North Westerly - PD zoning 5th Review (Staff Approval)

To: John Prestwich, PCS Group
From: Aly Burkhalter, Senior Planner
Date: May 8, 2025
Re: PD-001700-2024 North Westerly - PD

5th Review & Referral Comments

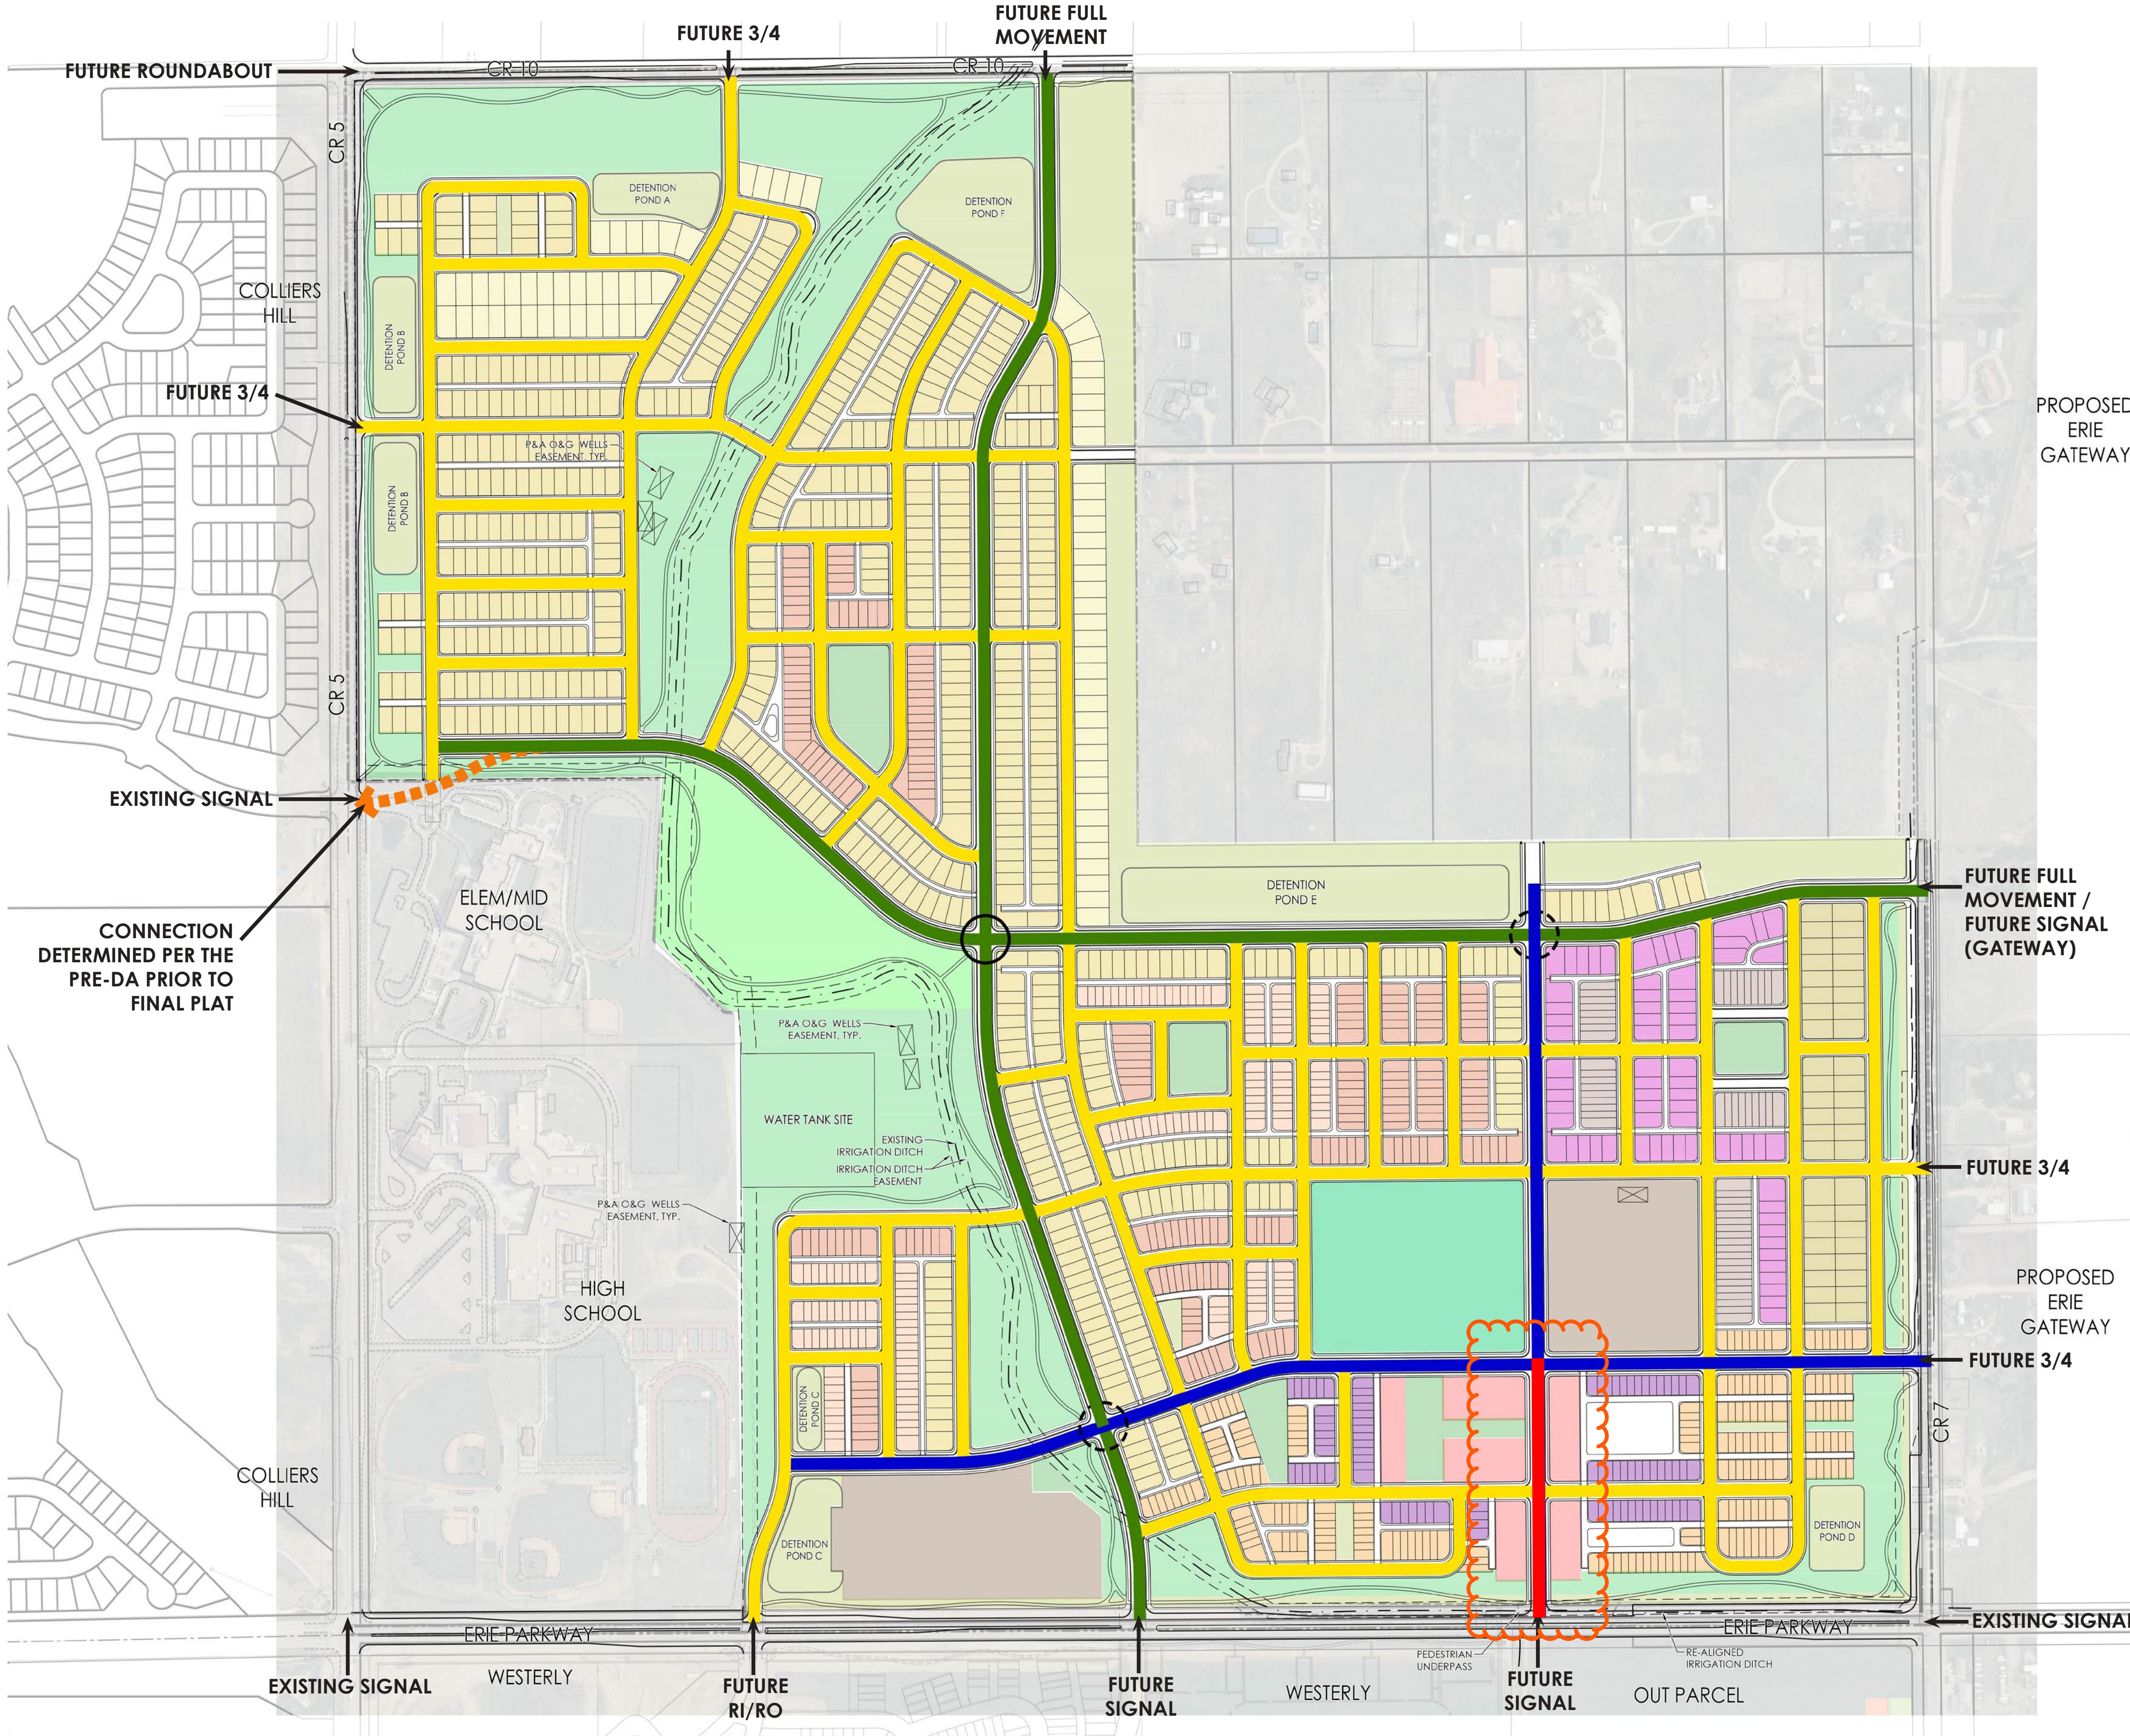
3. The town is concerned with the proposed traffic volume at the start of Main Street (9,760 ADT) as well as how that traffic is dispersed (the block closest the amenity center drops to 1,760 ADT). As a result, the town is requesting that the two blocks highlighted on the PD document be coded as a minor arterial (per TOE standards, minor arterial is <12,000) and each intersection (the arterial & minor collector intersection and the arterial & local street intersection) be investigated. Currently, only intersection 24 is investigated but is shown as a 4-way stop (should be a TWSC) and shows LOS A, which given almost 10k ADT, seems high.

Given the designated parking area for this commercial corridor is located to the east of Main Street, I would expect higher right turn/left turn volumes at these intersections than what is currently shown. Please update these two intersections given that a majority of the ADT in this area will be turning to utilize the designated parking area.
